**CITY OF ISANTI  
PLANNING COMMISSION MEETING  
TUESDAY, February 15, 2022  
Immediately Following the 7:00pm City Council Meeting  
CITY HALL**

SUBJECT: Site Plan Review and CUP Approval for a Commercial building for Little North Boutique with a drive-thru located at 291 5<sup>th</sup> Ave NE

**Date:** February 7, 2022  
**To:** Stephanie Hillesheim, Community Development Director  
**From:** Jason W Cook, P.E.  
City Engineer  
**Subject:** Little North Boutique - Plan Set - Engineering Review  
City of Isanti, MN  
Project No.: 0R1.123130

4 EAST ELEVATION  
A2 1/8" = 1'-0"

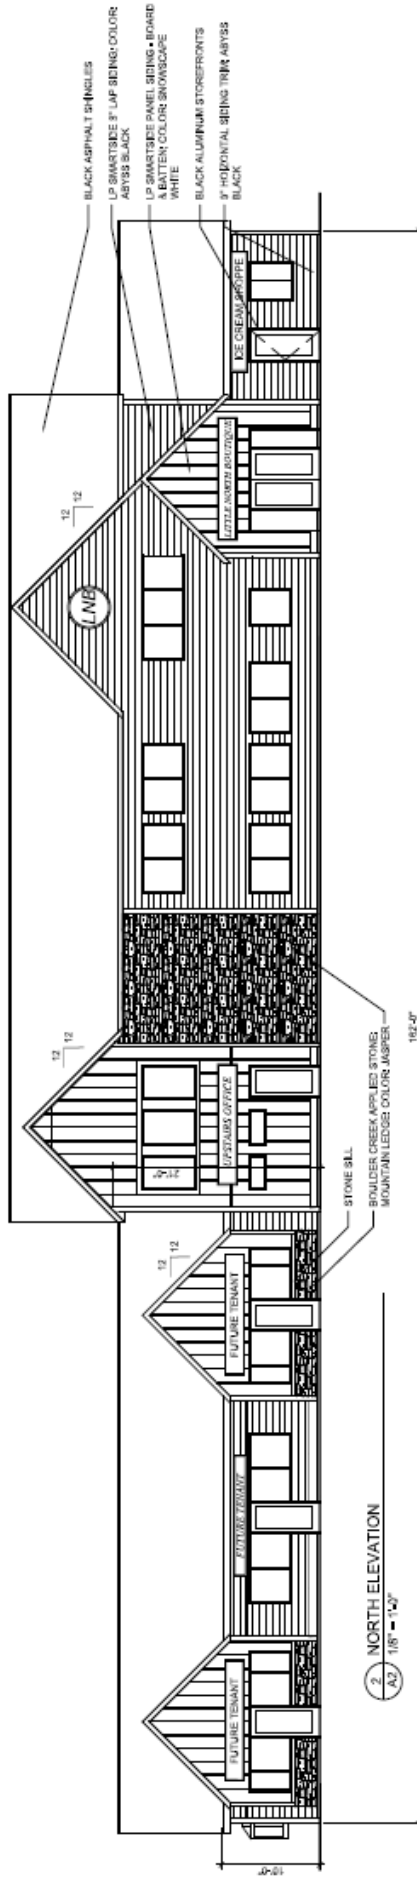
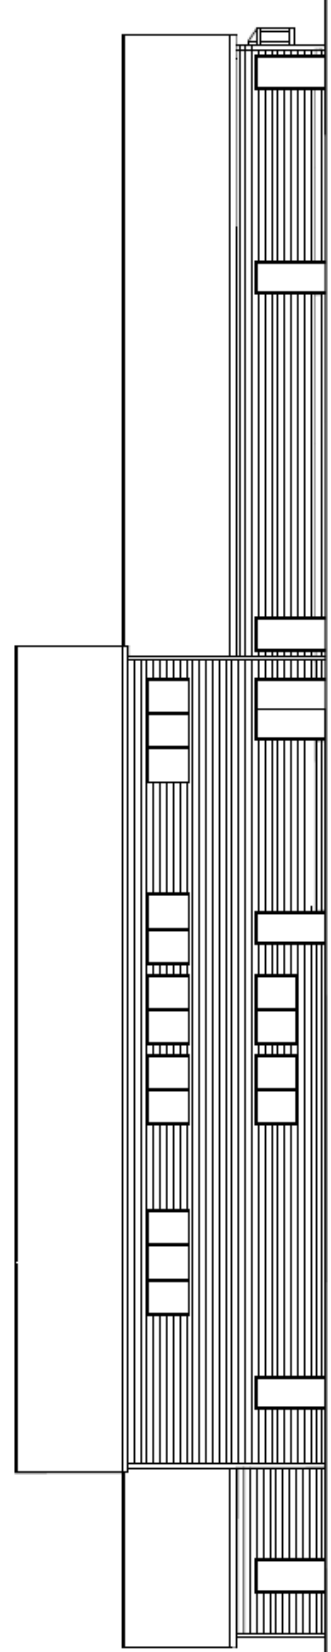
6. Masonry stucco.
7. Other comparable or superior material as recommended by the Planning Commission and approved by the City Council.
8. No more than 75% of the building sides visible from Highway 65 may be constructed of decorative concrete block, pre-cast concrete or stucco.

9. The exterior of the building shall have varied and interesting detailing. Large unadorned walls shall be prohibited (50' or more). All large walls viewable from Highway 65 must be relieved by architectural detailing, such as change in materials, change in color, offsets, or other significant visual relief provided in a manner or at intervals in keeping with the size, mass and scale of the wall and its views from the public right-of-way.

10. Exterior building material colors shall be complimentary of other buildings within the district.
11. Exterior elevations of all sides of a proposed building noting the material and color of each component, to include exterior building materials, awnings, mechanical screening material, fencing and the like, shall be submitted with the site plan for determination of compliance with the above requirements.
12. Mechanical equipment
  - a. Ground equipment shall be screened per Section 14, Subdivision 4 Mechanical Equipment.
  - b. Rooftop mechanical equipment, and head-houses for elevators and stairs, shall be concealed from public view.

5. Sheet C8 – Utility Plan:

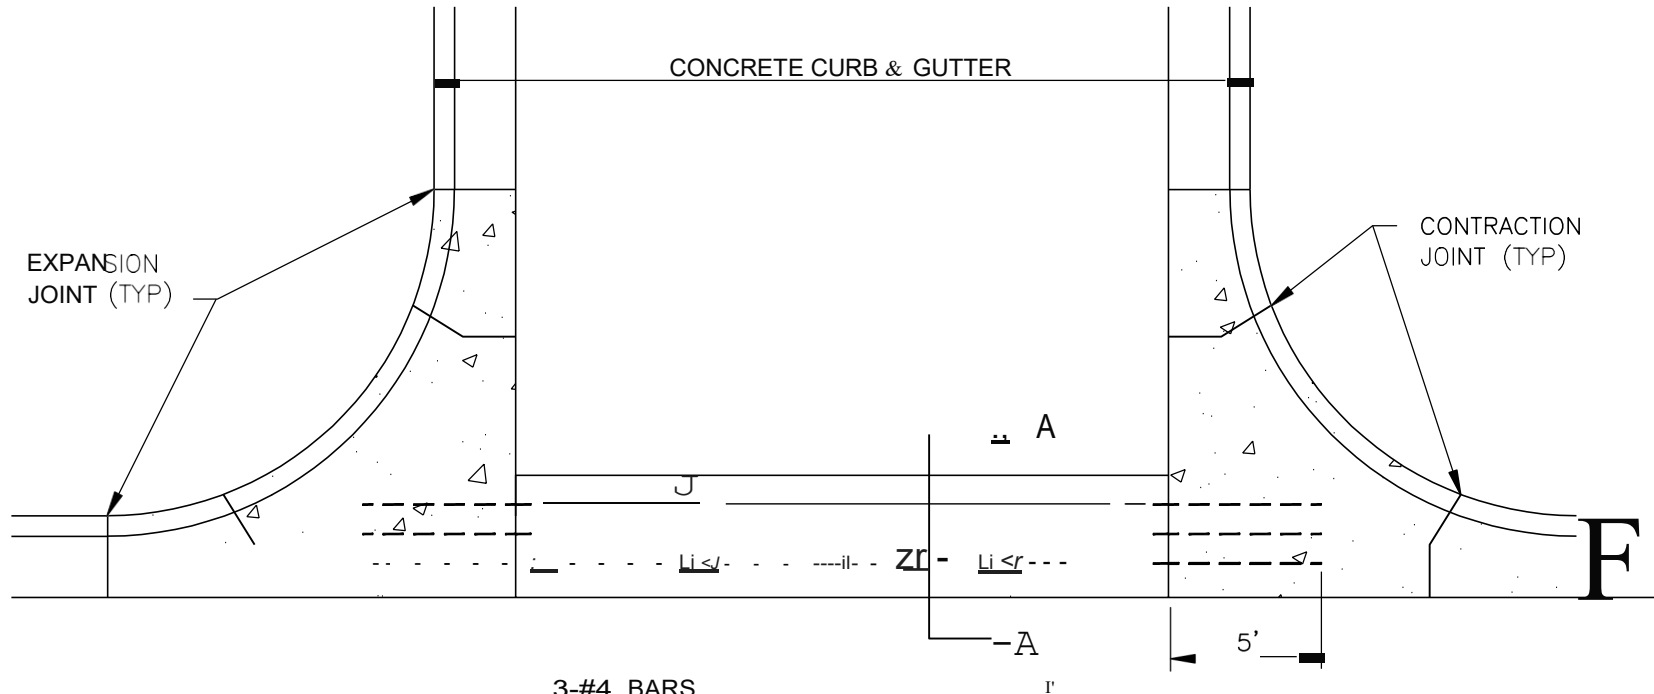
- a. Need separate sewer and water services for each tenant space if they plan to be metered separately.
  - b. A 6" PVC sanitary sewer service and 6" DIP water service are already stubbed to the property line. See attached record drawing. Connect to this service, as opposed to cutting into the street.
    - i. Label pipe slopes and inverts, as well as cleanouts as needed.
  - c. Need a detail on the outlet control structure & call out riprap at all outlet aprons into pond and into ditch.
  - d. Need utility easement covering storm pipe and pond on Lot 2 in favor of Lot 1.
6. Sheet L1.1 – Landscape Plan:
- a. No tree plantings within 10 feet of sanitary or water services.

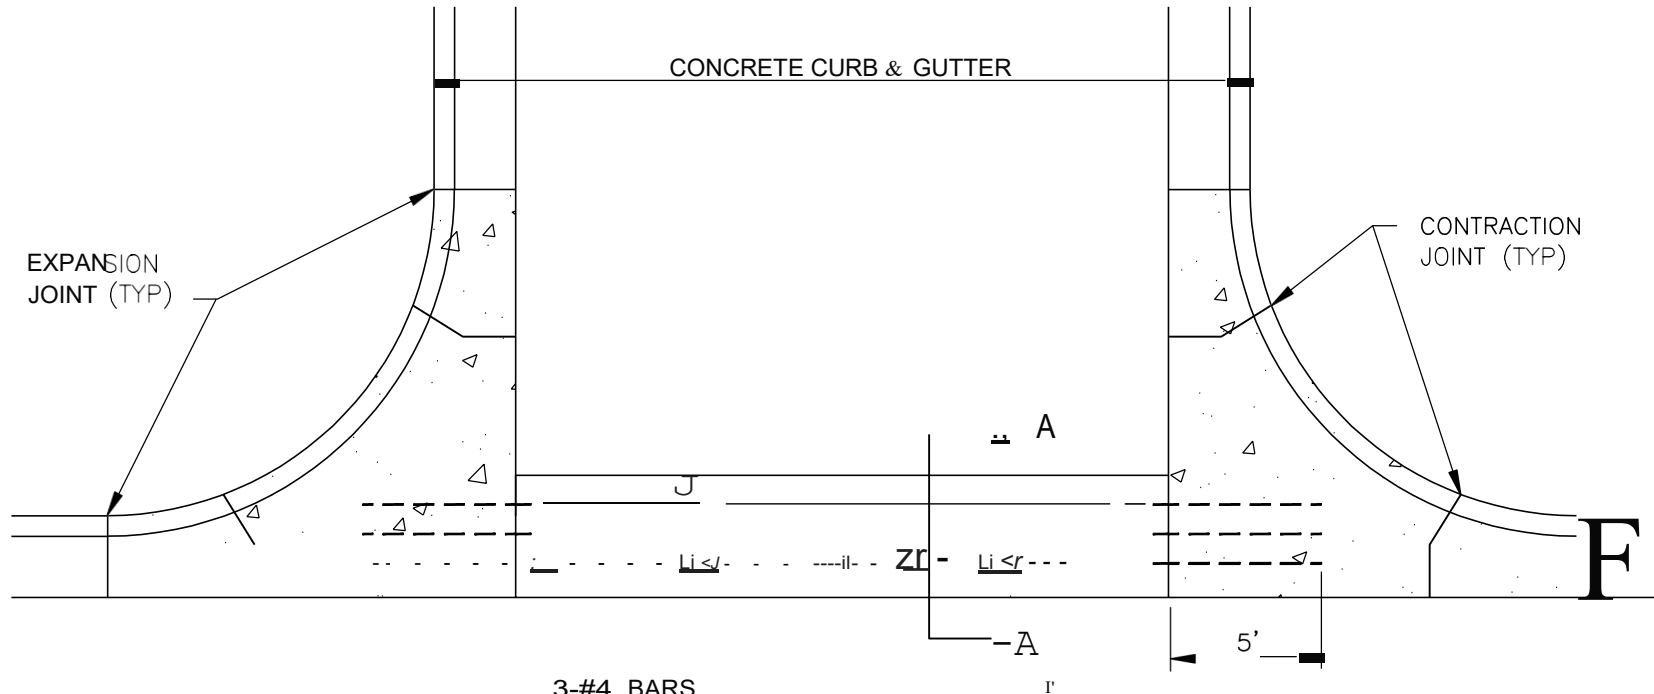
- b. The sanitary sewer service line is not shown.
    - i. Label pipe slopes and inverts, as well as cleanouts as needed.
  - c. Need a detail on the outlet control structure & call out riprap at all outlet aprons into pond and into ditch.
6. Sheet L1.1 – Landscape Plan:
- a. No tree plantings within 10 feet of sanitary or water services.

CONCRETE VALLEY GUTTER		BMI DETAIL PLATE NO: 7-100	APPROVAL: STDS COMM. SPRING, 2006	DATE:	DETAIL LOG
PATH: Y:\7-100		REVISIONS:			
ORIG. PROJ:		REMARKS:			
PROJ. #:		ENG/TECH:

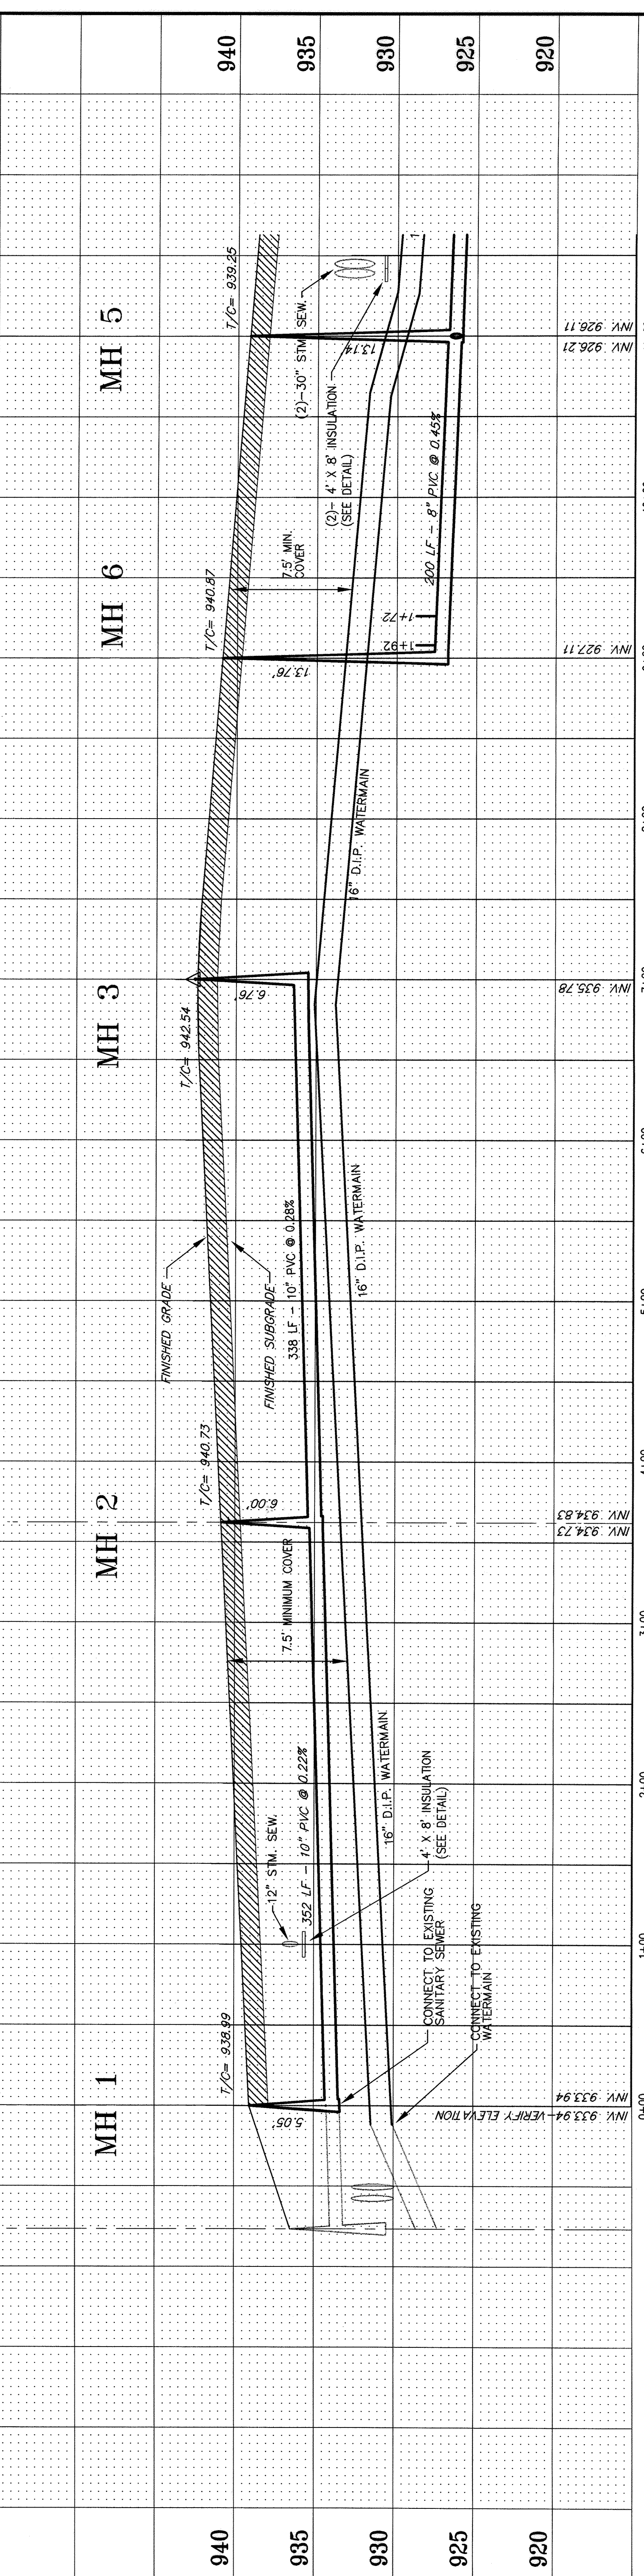
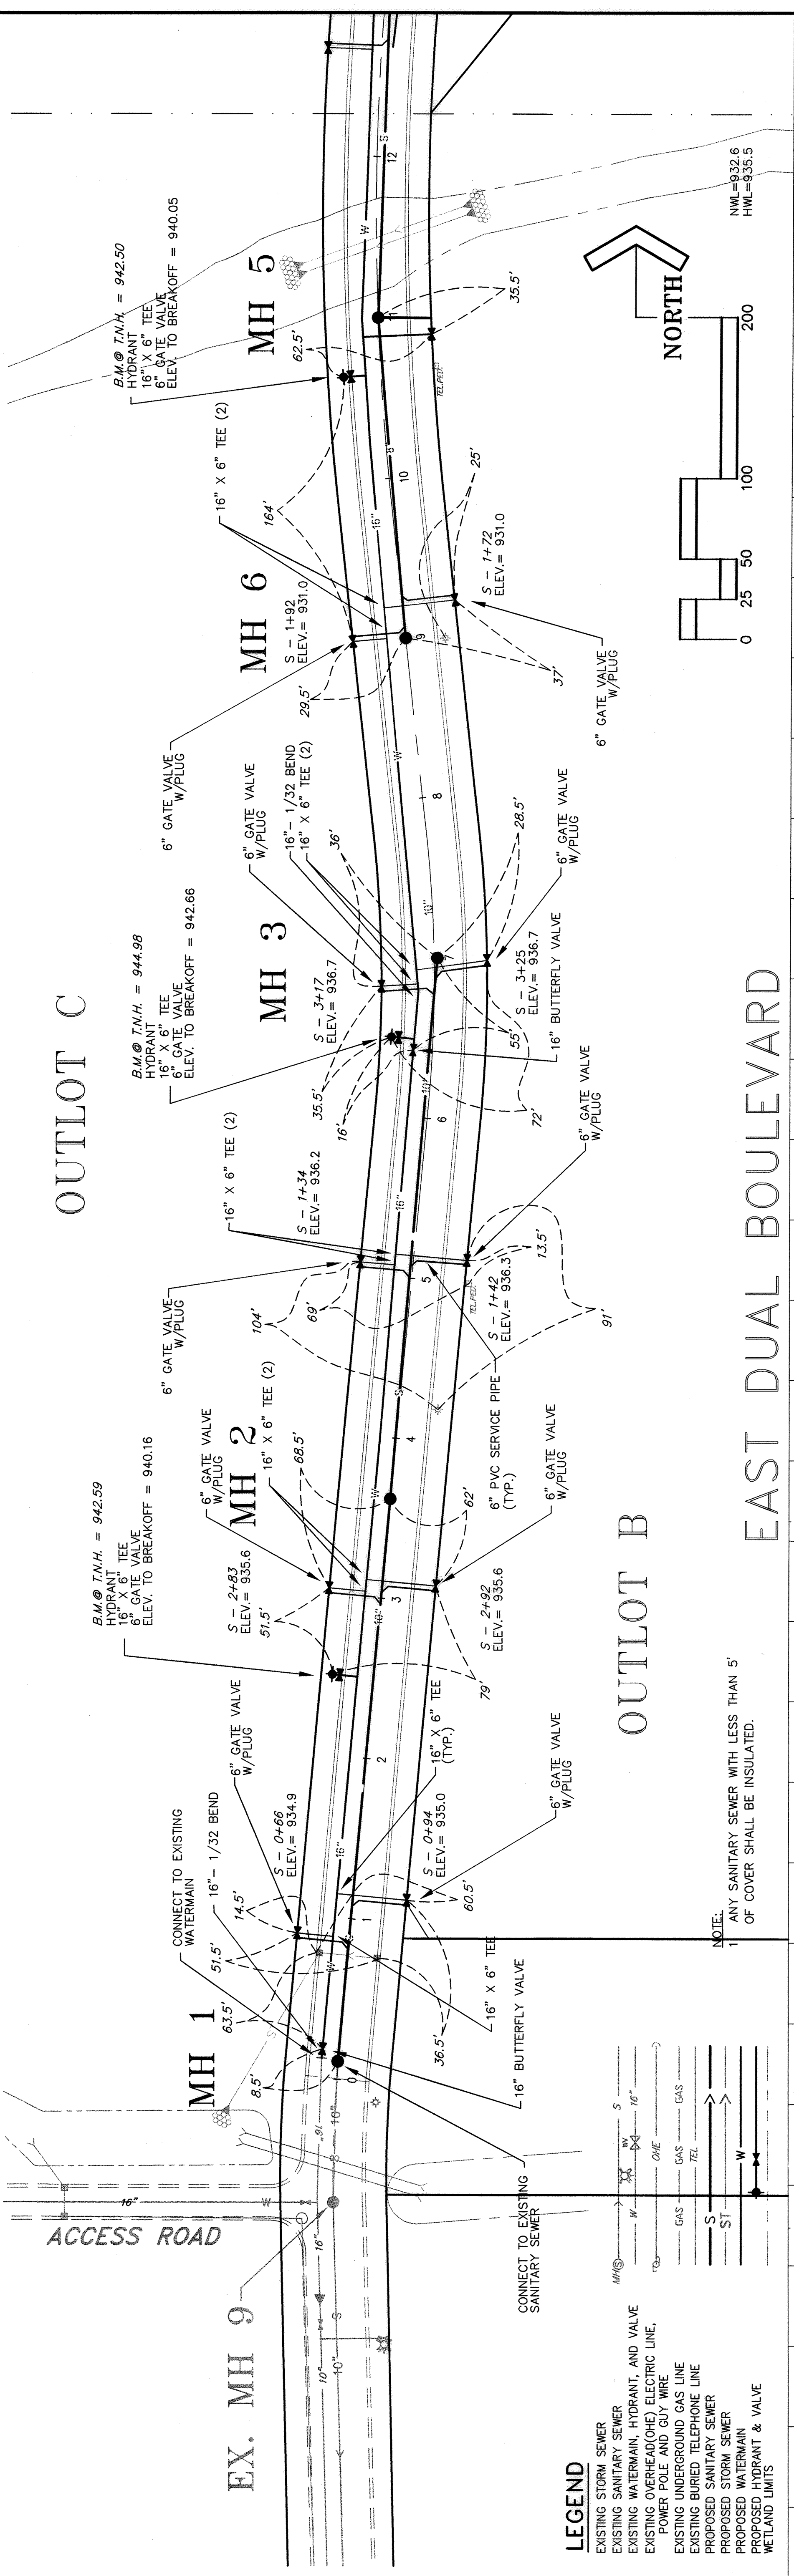
- b. Construct valley gutter on East Dual Boulevard – (see attached detail)
2. Sheet C 3 of 6 – Grading & Drainage Plan:
  - a. The storm water ponds will need to have an impervious liner to ensure no infiltration occurs and the dead storage is maintained.
